WM-40

Gregory G. Eadie
Office of Nuclear Material
Safety and Safeguards (MS 483-SS)
U.S. Nuclear Regulatory Commission
Washington, D.C. 20555

I have reviewed the working paper titled "Recommended Procedures for Identifying Properties that Require Remedial Action, and for Verifying that Remedial Action Has Been Successful." My comments are both general and specific in nature, and opinions expressed are solely my own and may or may not reflect other ORP staff opinions.

ENCLOSURE 1

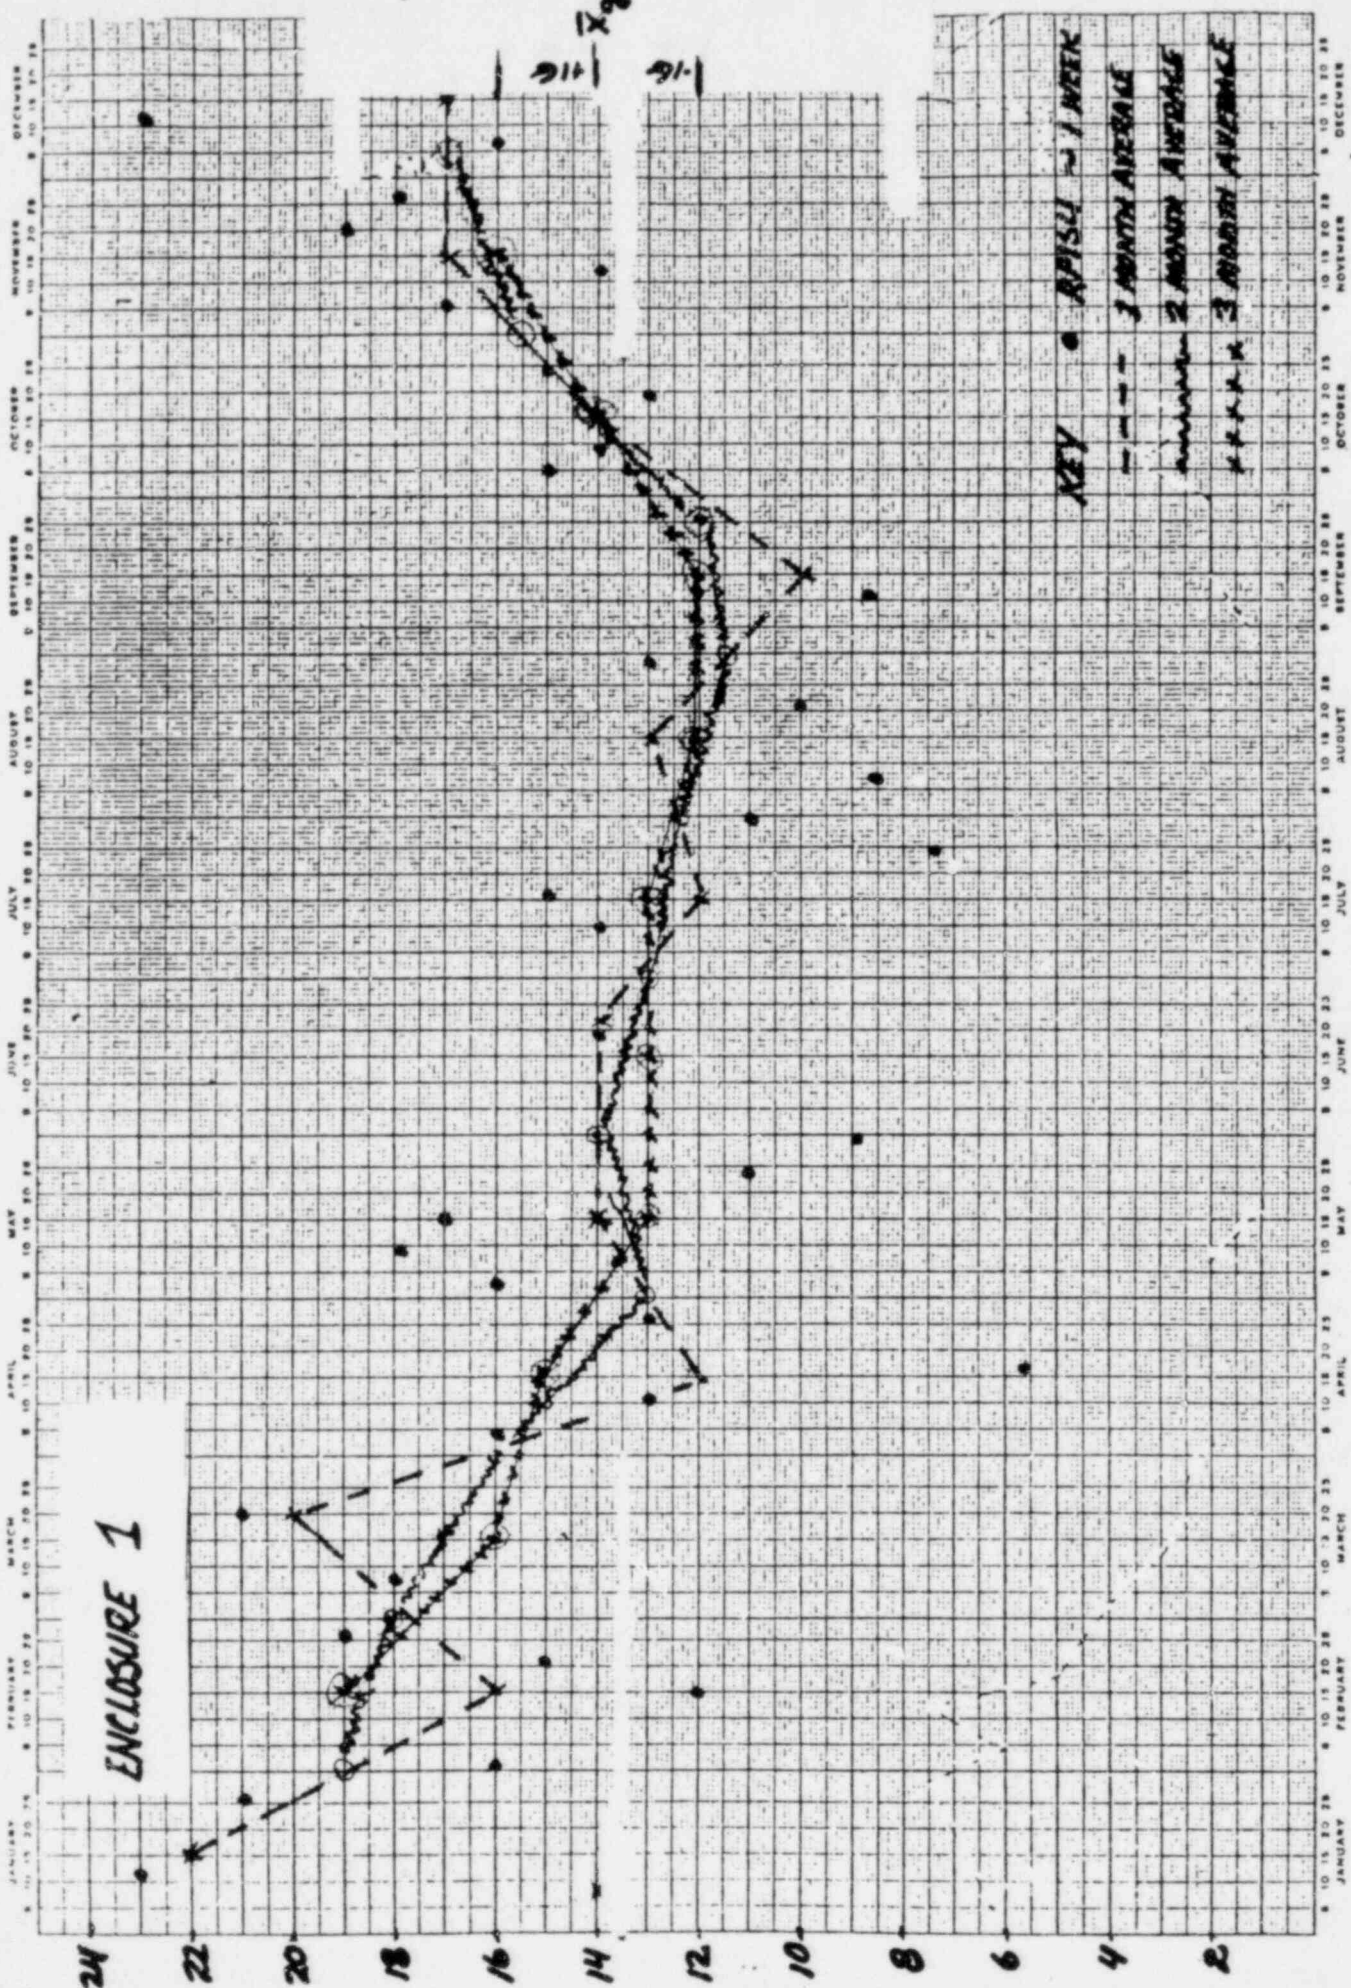
Fortunately, some annual WL data does exist and some approaches to estimate the AAWL can be explored. Enclosure 1 is a plot of individual RPISU measurements made in a public building located in Butte, MT. The individual data points (dots) are quite variable. The 1, 2, and 3 month averages of the individual WL measurements indicate a seasonal trend. Enclosure 2 is a plot of the individual data points on log-probability paper. The distribution is log-normal with a geometric mean of 0.014 WL and a geometric standard deviation of 1.37. The geometric mean is about the best estimate of the true mean possible using RPISU's.

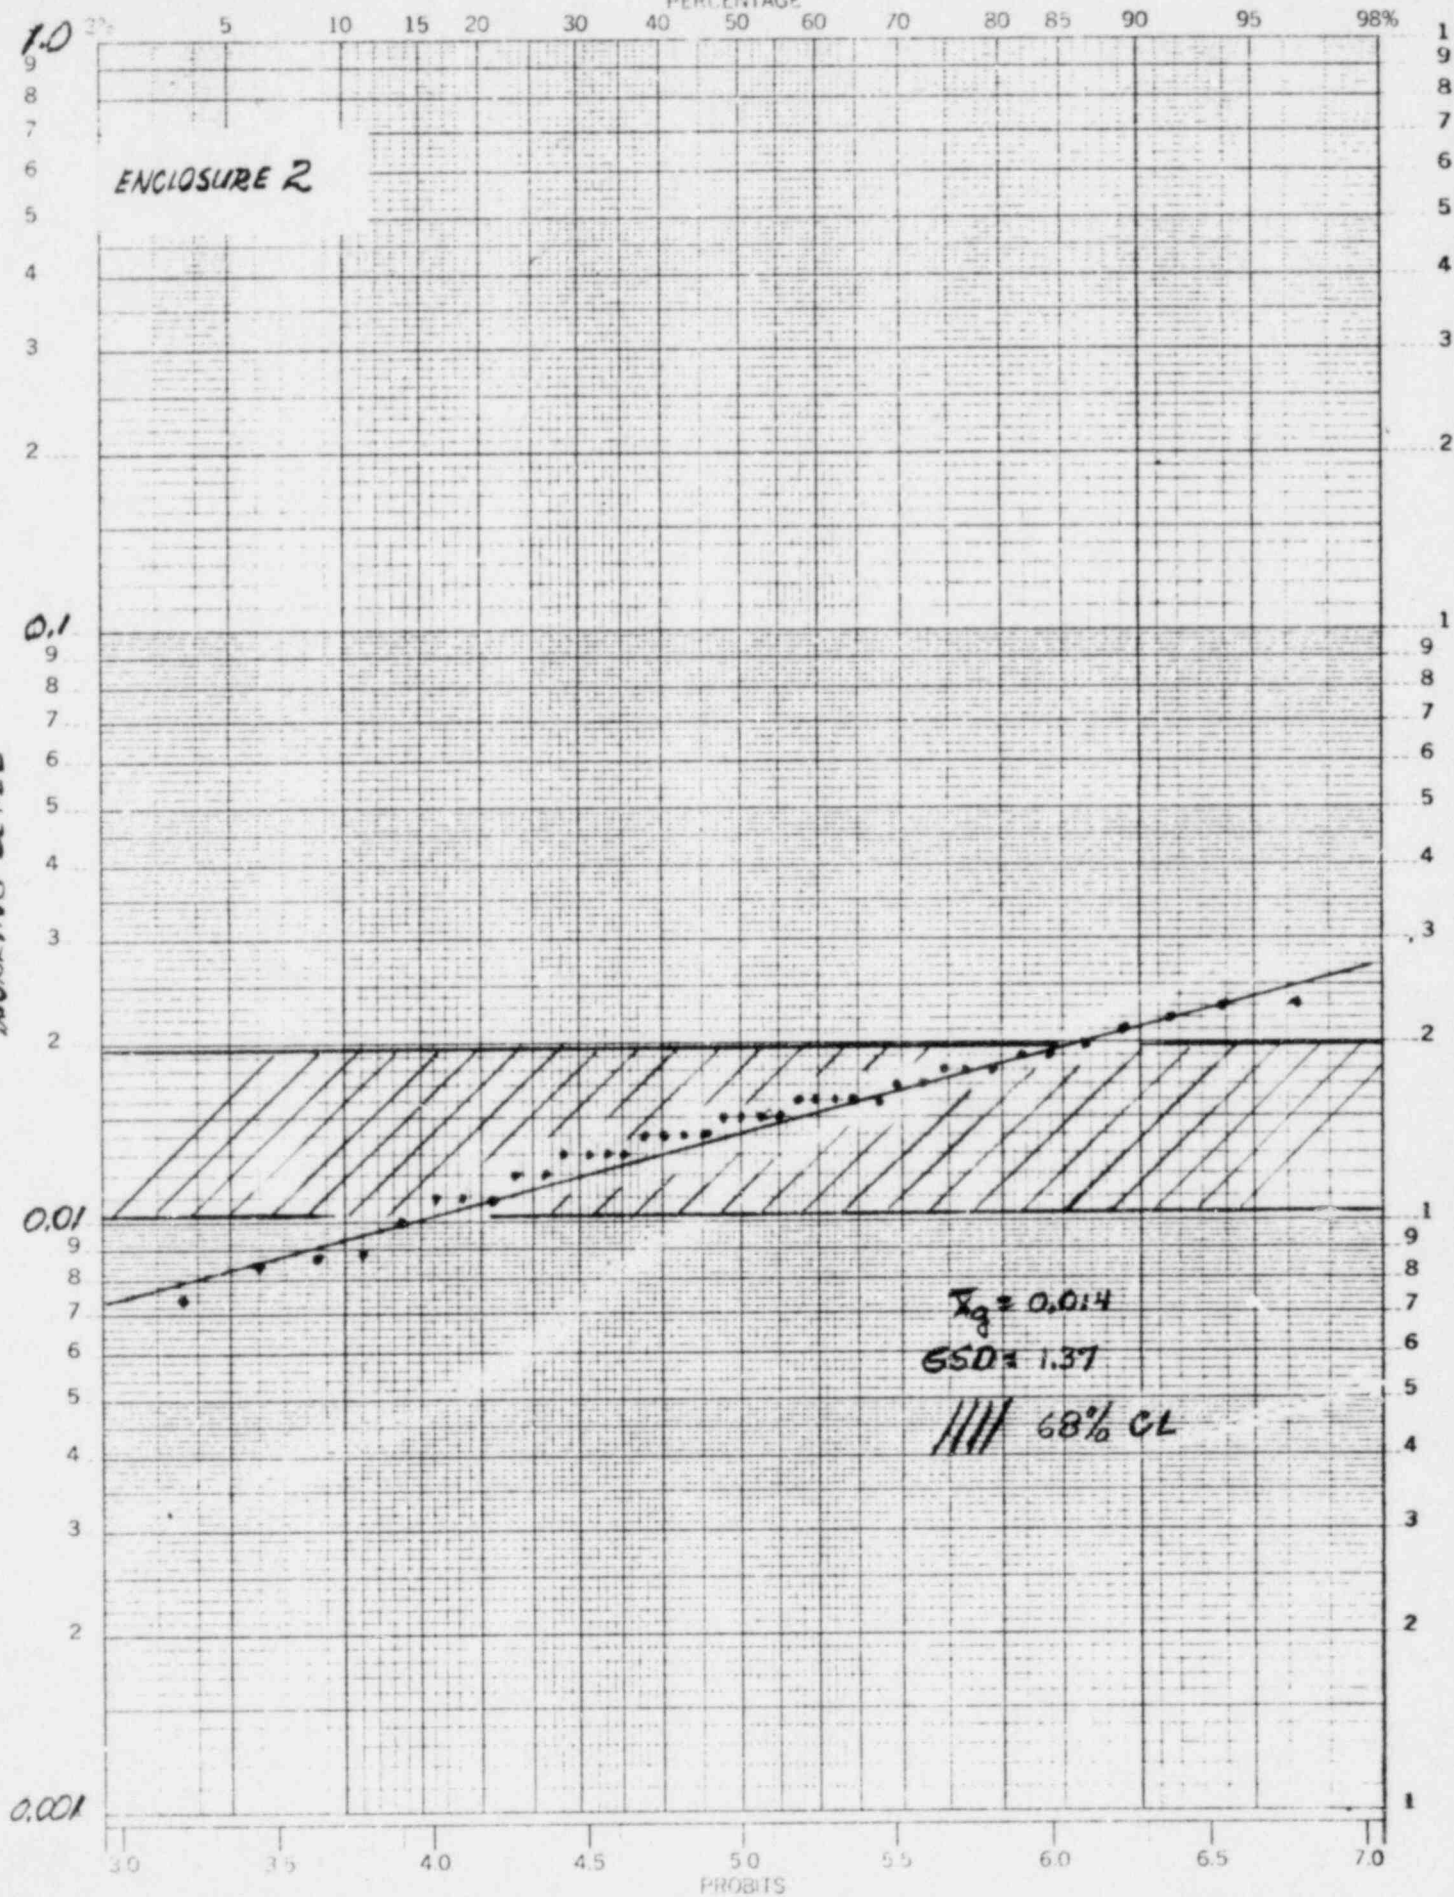
A one-week RPISU sample may provide a similar screening measurement. With regard to Enclosure 2, if any single RPISU sample collected over a period of one week exceeds 0.028 WL, it is likely that the AAWL will exceed 0.015 WL at the 95% confidence level. Correspondingly, a single RPISU sample will be within +86% and -49% of the geometric mean at the 95% confidence level.

ENCLOSURE 3

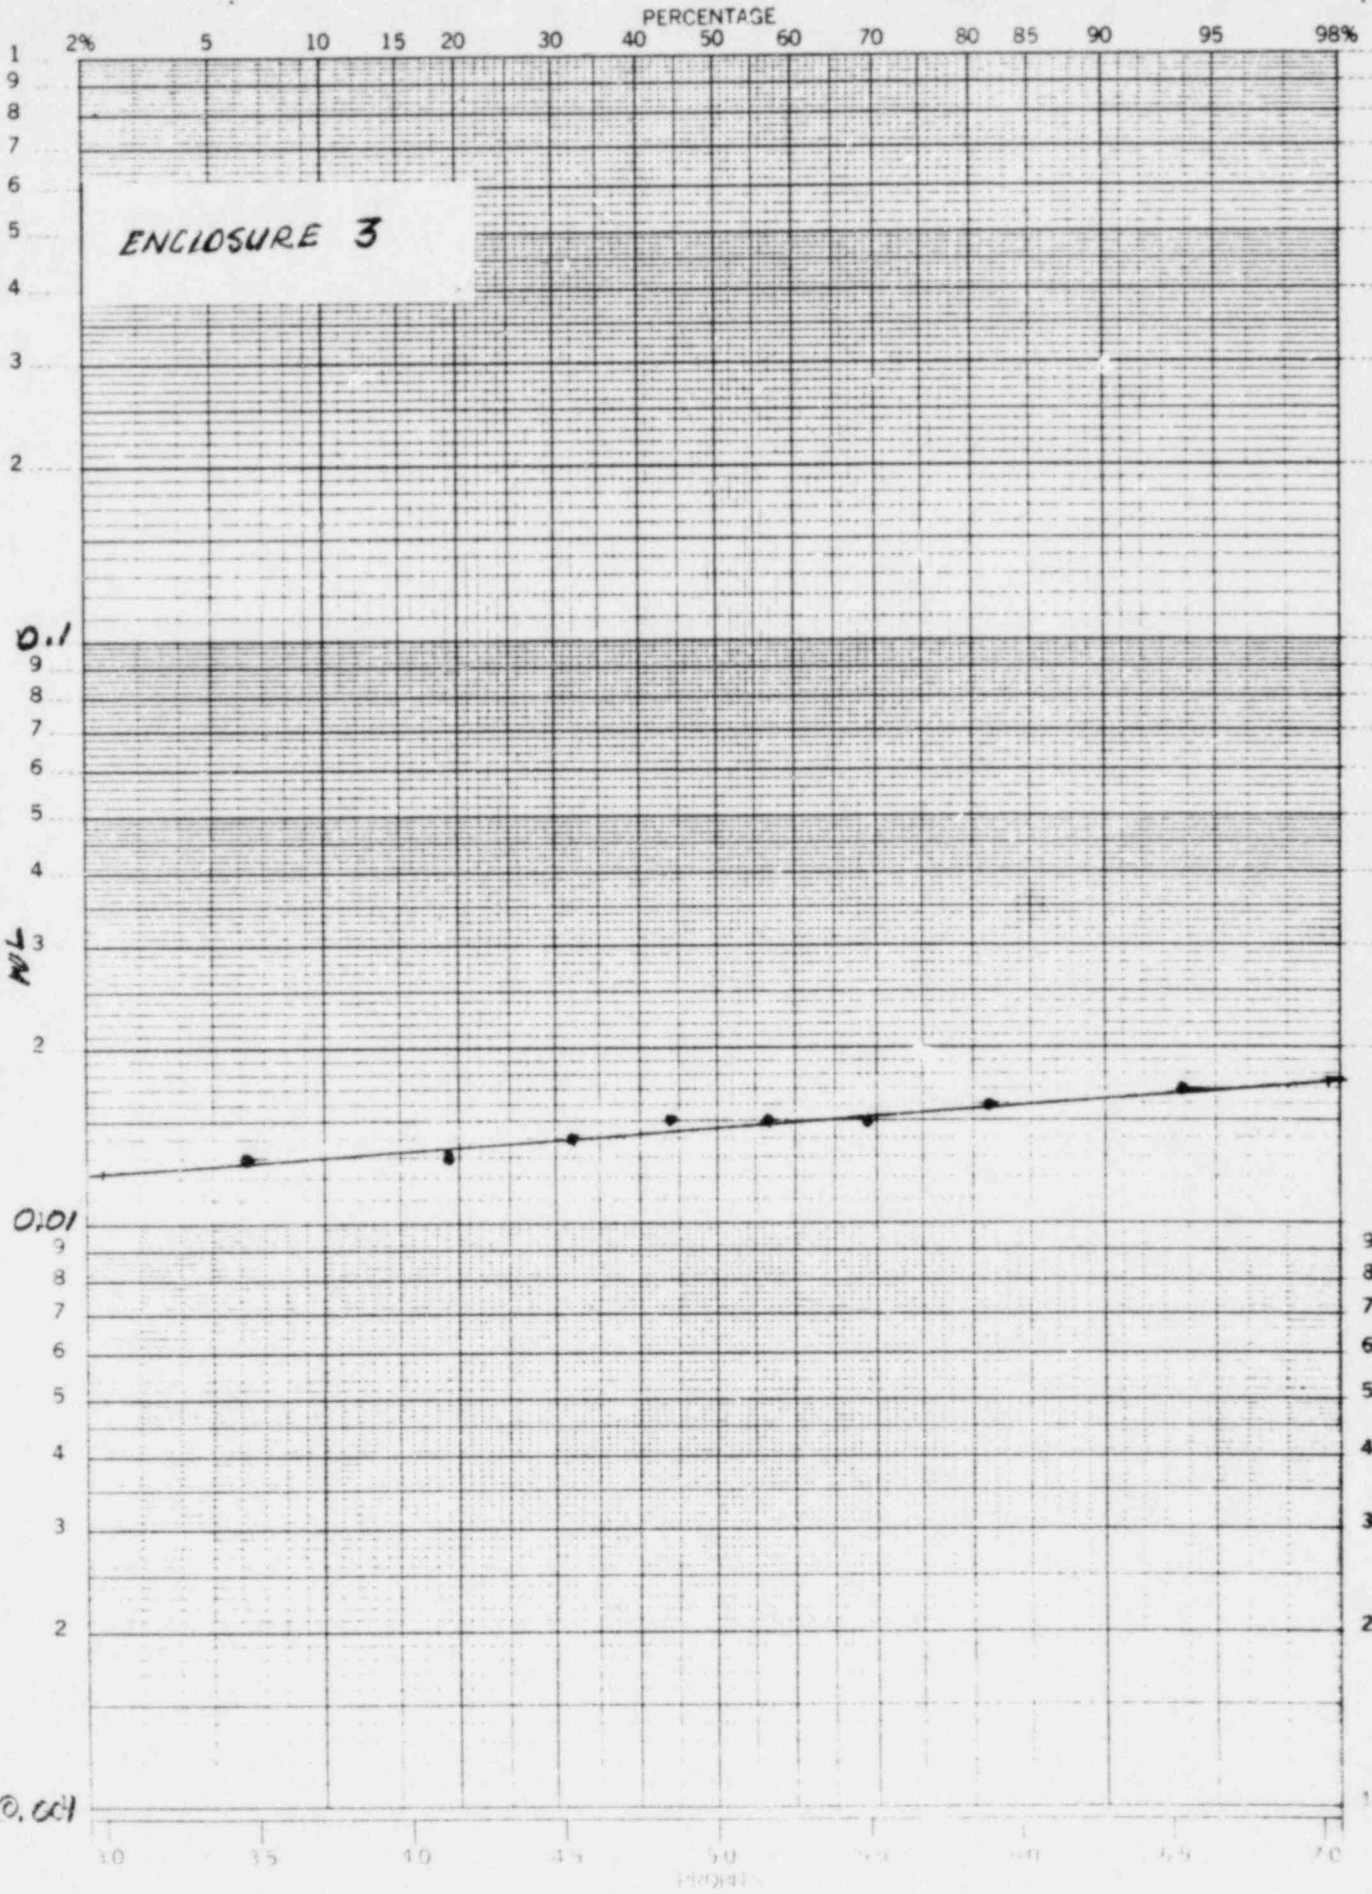
Using the second approach (short-term samples spaced over a period of one year) requires more time than grab sampling but produces better results. Enclosure 3 is a log-probability plot of 8 sets of the arithmetic average of 6 samples spaced approximately 2 months apart (i.e., Surgeon General's Criteria for Grand Junction, Colorado). They are within +21% and -16% of the geometric mean at the 95% confidence level. The line fit has a correlation coefficient of 0.97. If we extend the sampling interval to 3 months and plot 6 sets of the arithmetic average of 4 spaced samples, we obtain a log-normal plot (Enclosure 4). The data points are within +38% and -26% of the geometric mean at the 95% confidence level. This line fit has a correlation coefficient of 0.89.

ENCLOSURE 5

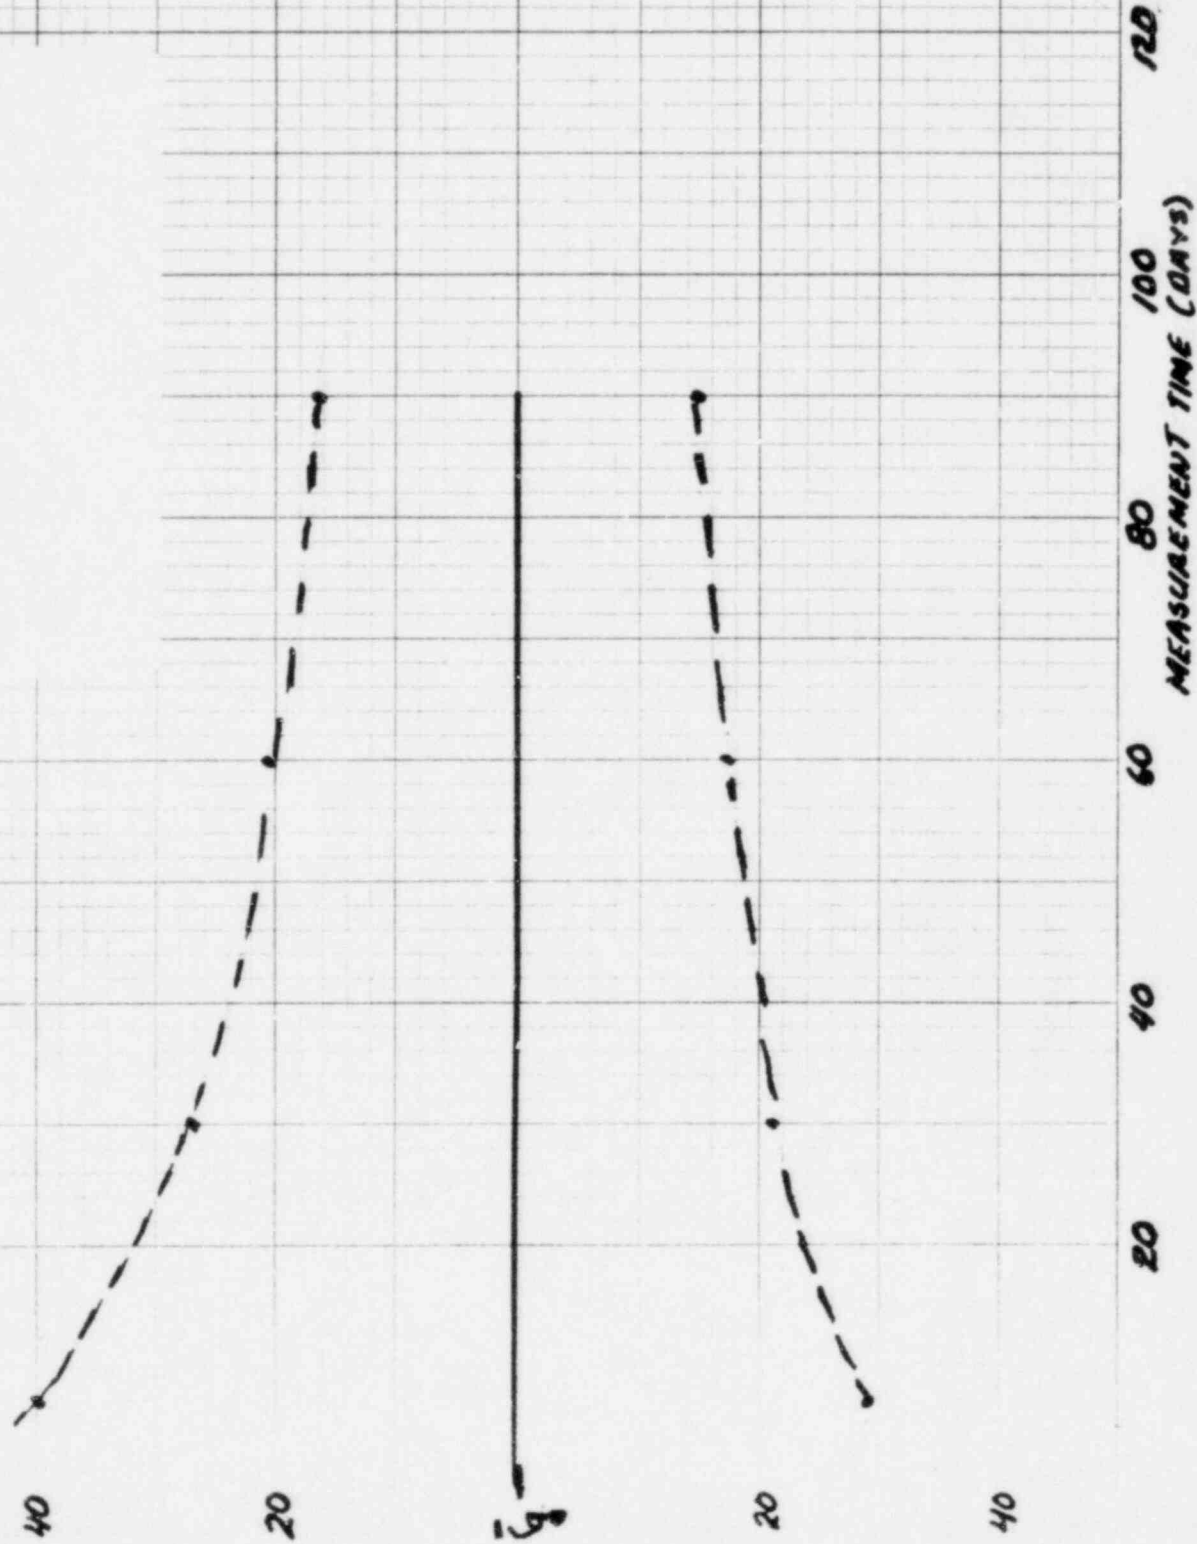
Enclosure 5 is a presentation of how the geometric standard deviation changes using the third approach (i.e., assuming a continuous sampling period up to 90 days). The dashed line represents a plot of the geometric standard deviation as a percentage of the geometric mean with increasing sampling times. All possible combinations of consecutive 30, 60, and 90 day sampling periods were each plotted on log-probability paper and their geometric standard deviations were measured. You can improve the error by sampling for longer consecutive periods of time. Unfortunately the error at the 95% confidence level for a 90 day sampling period is +36% and -25% of the geometric mean. Seasonal variations undoubtedly contribute to this spread. The error may be reduced somewhat by selecting a particular sampling period during the year.
